**GOODWIN UNIVERSITY EDUCATIONAL SERVICES, INC.**  
**Special Meeting of the School Building Committee**  
**May 12, 2026 at 12:00 pm**

Goodwin University  
Magnet Technical High School  
State Project #542-0007 MAG/N

**Subject: Progress Report**

A1.31

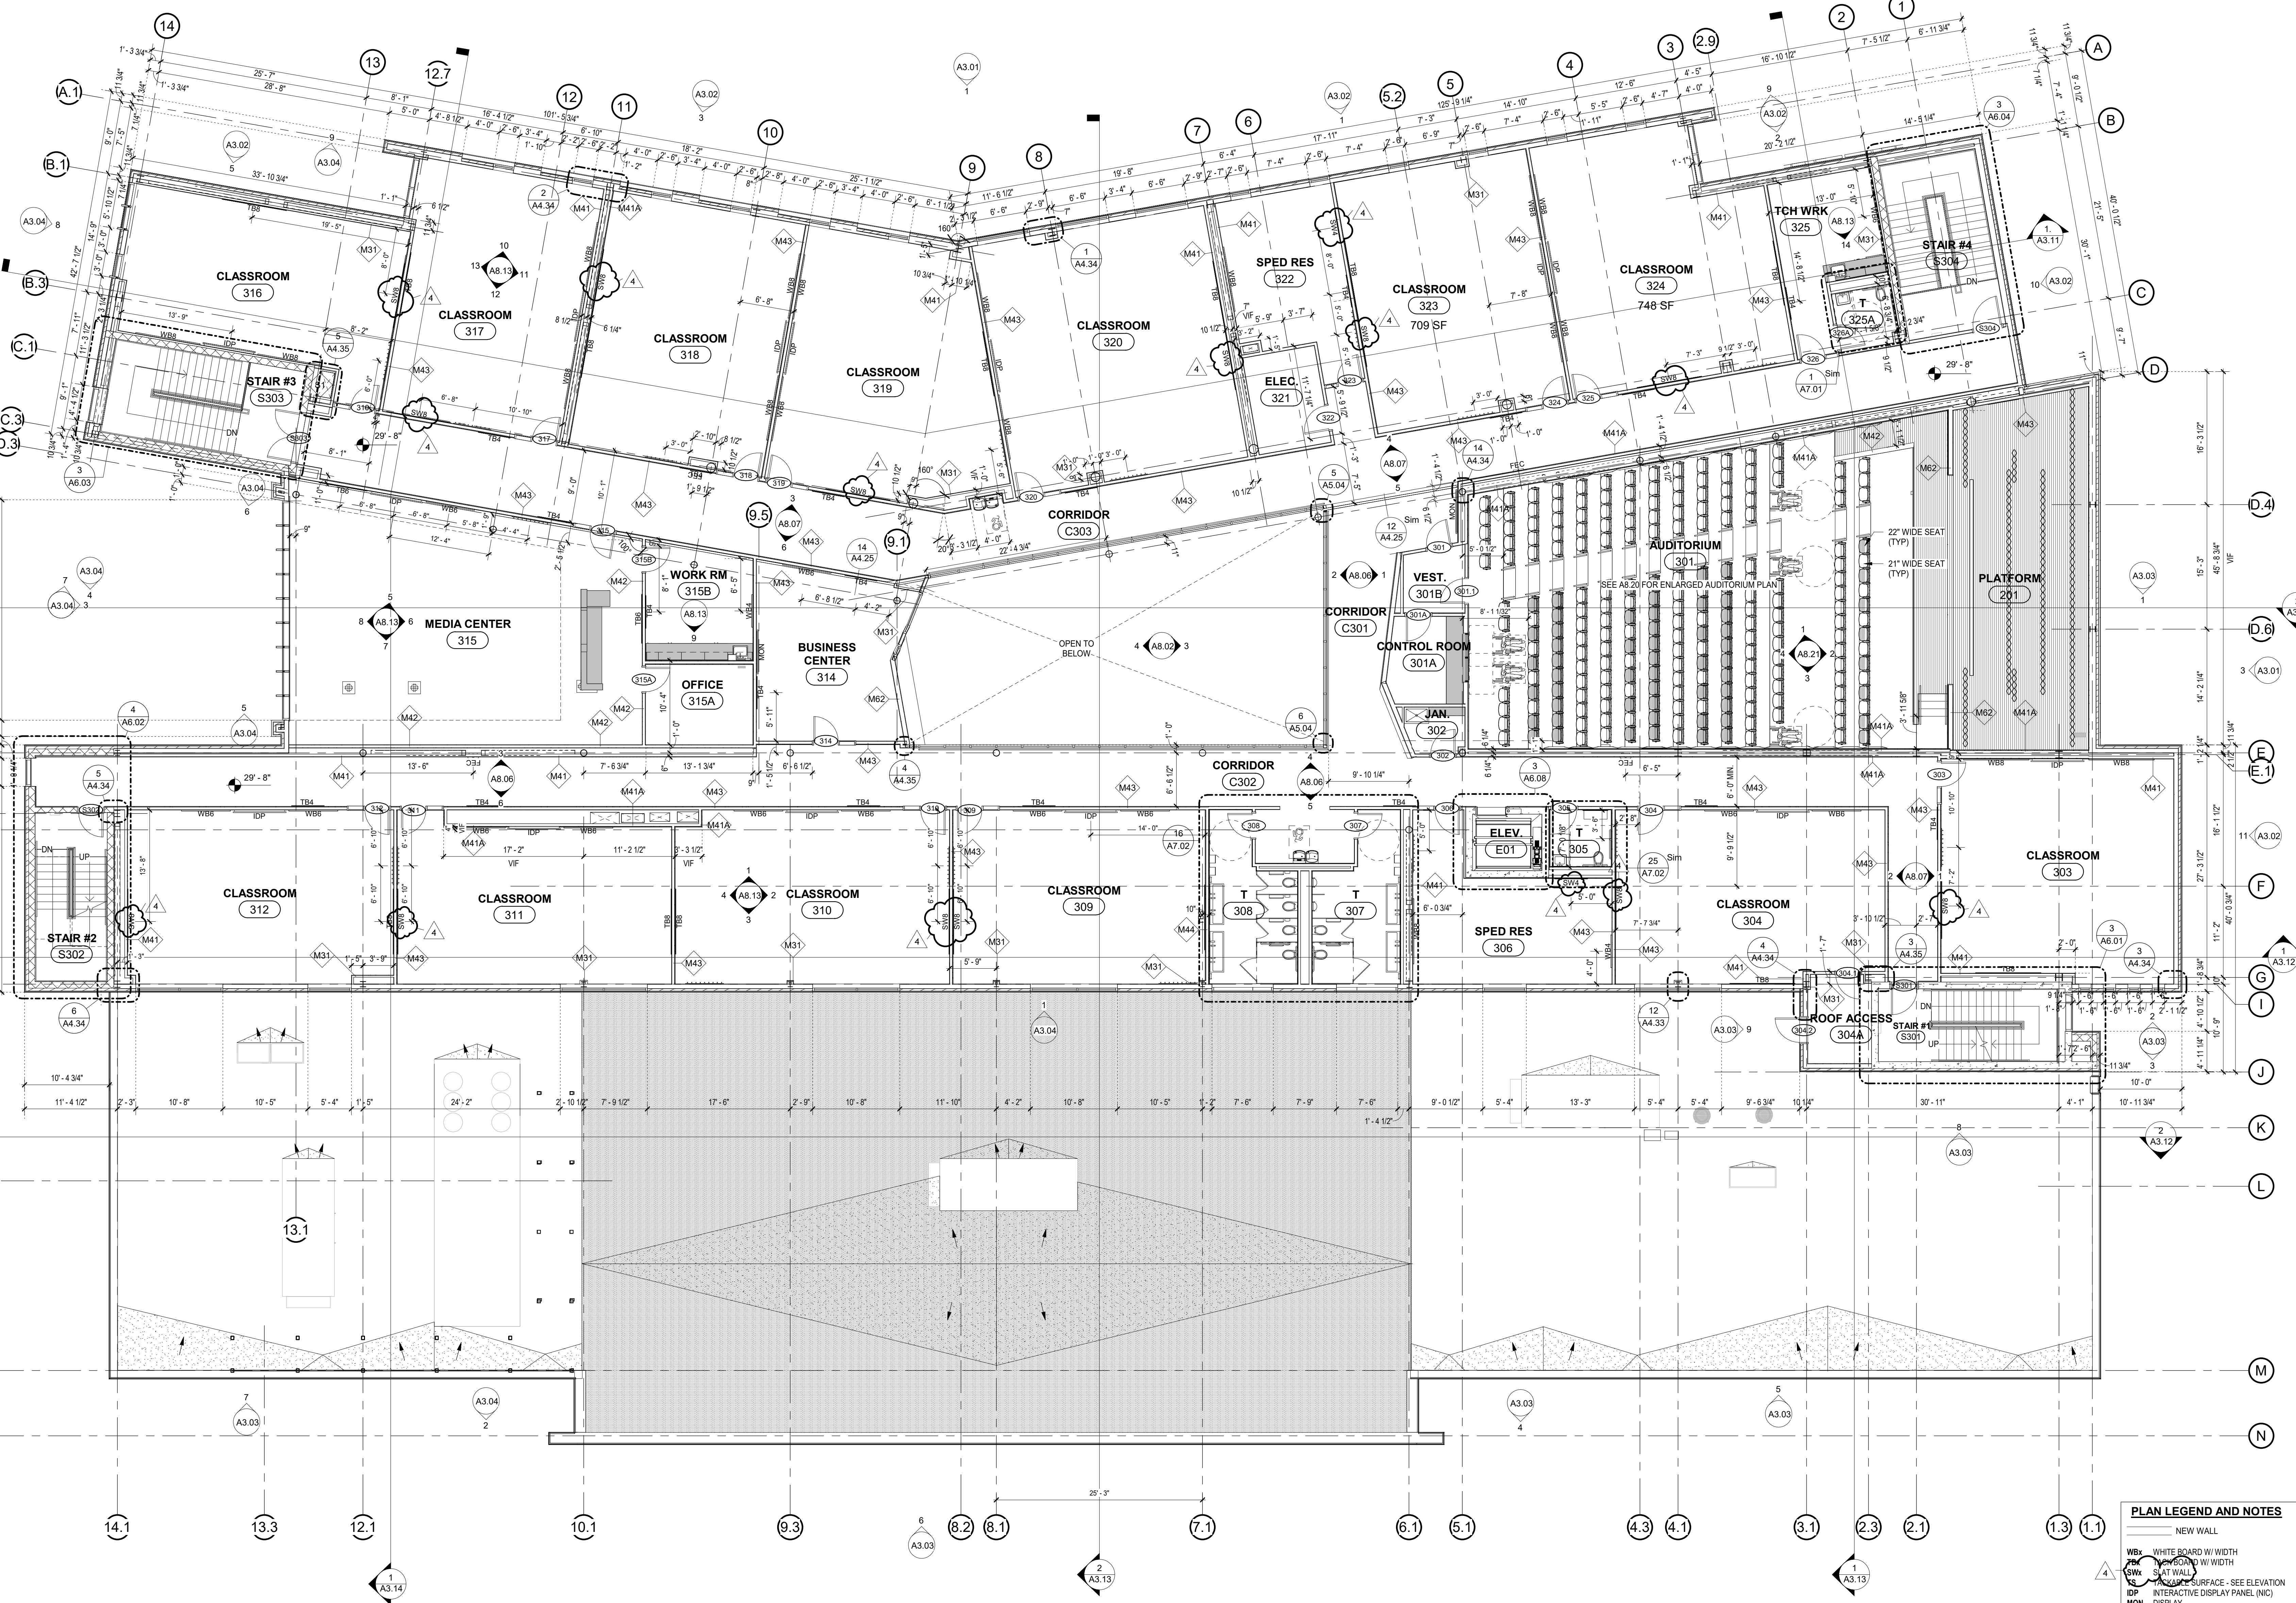
Please provide a cost proposal **to add slat wall or replace TB with a slat wall** as indicated on attached floor plans and take-off documents.

A1.11

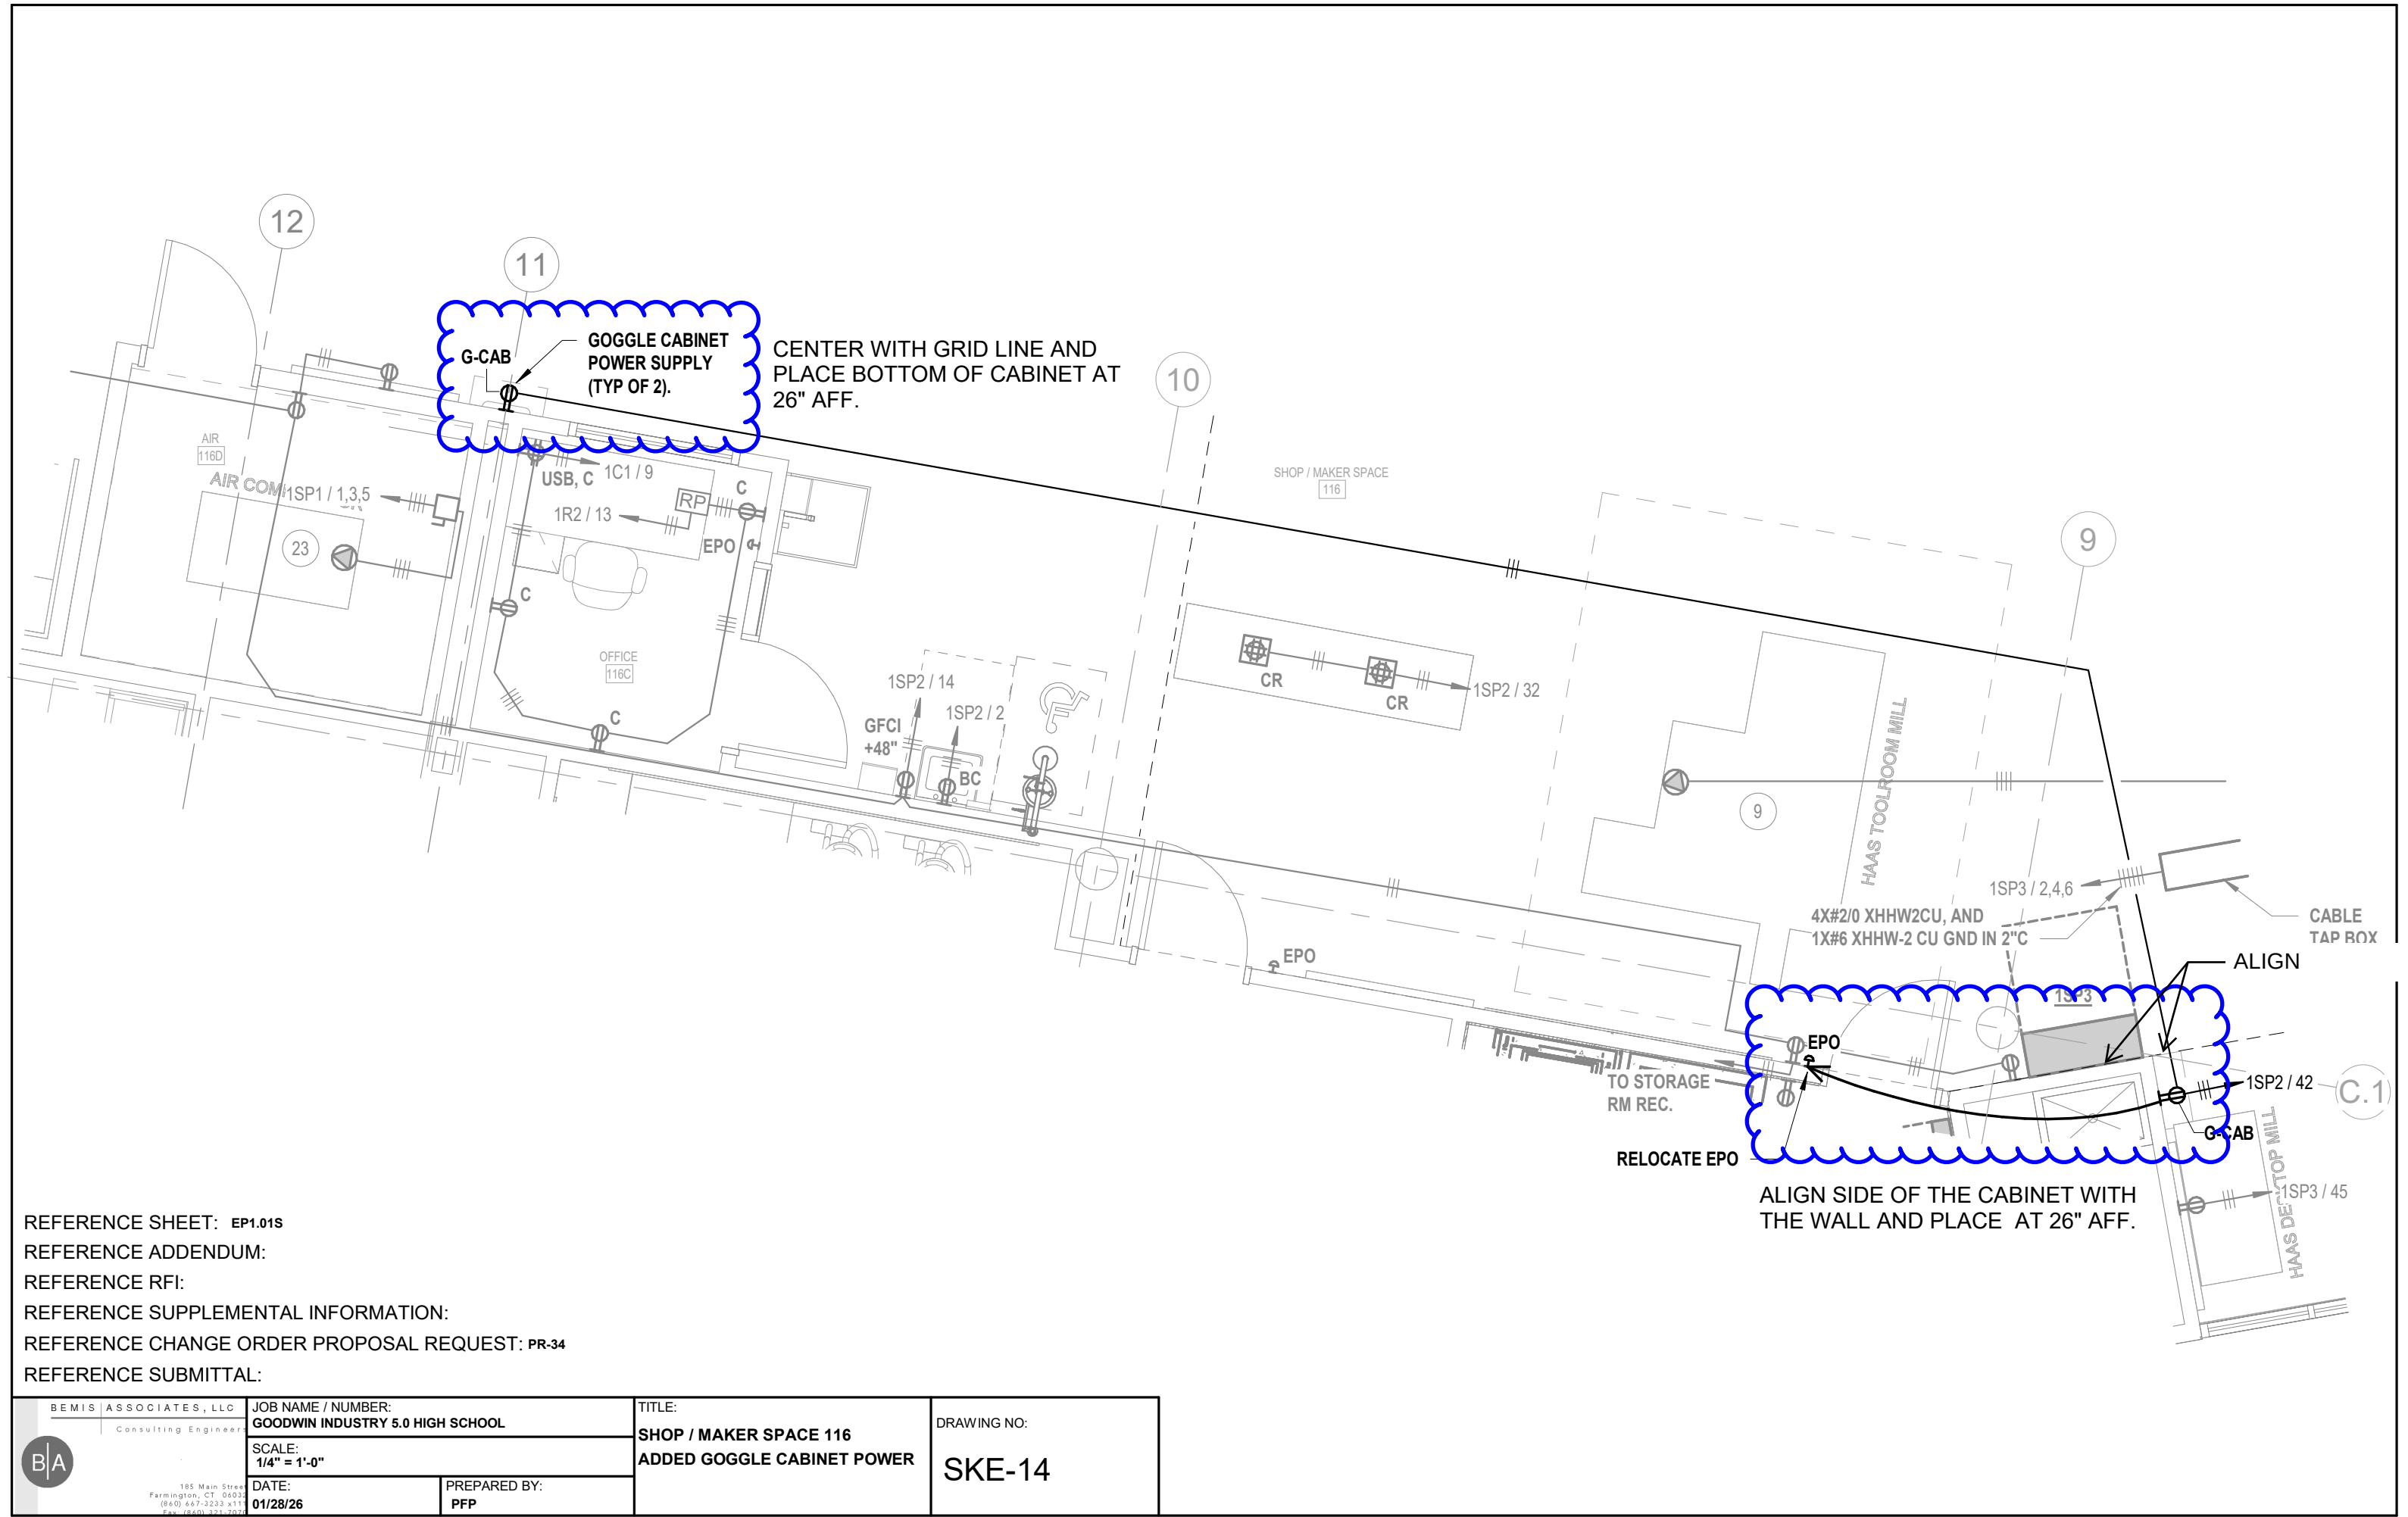
Please provide a cost proposal **to add two google sanitizing cabinets, similar to the one used in Science Labs, and one fire extinguisher and cabinet** in the Shop / Maker Space 116 based on attached sketches.
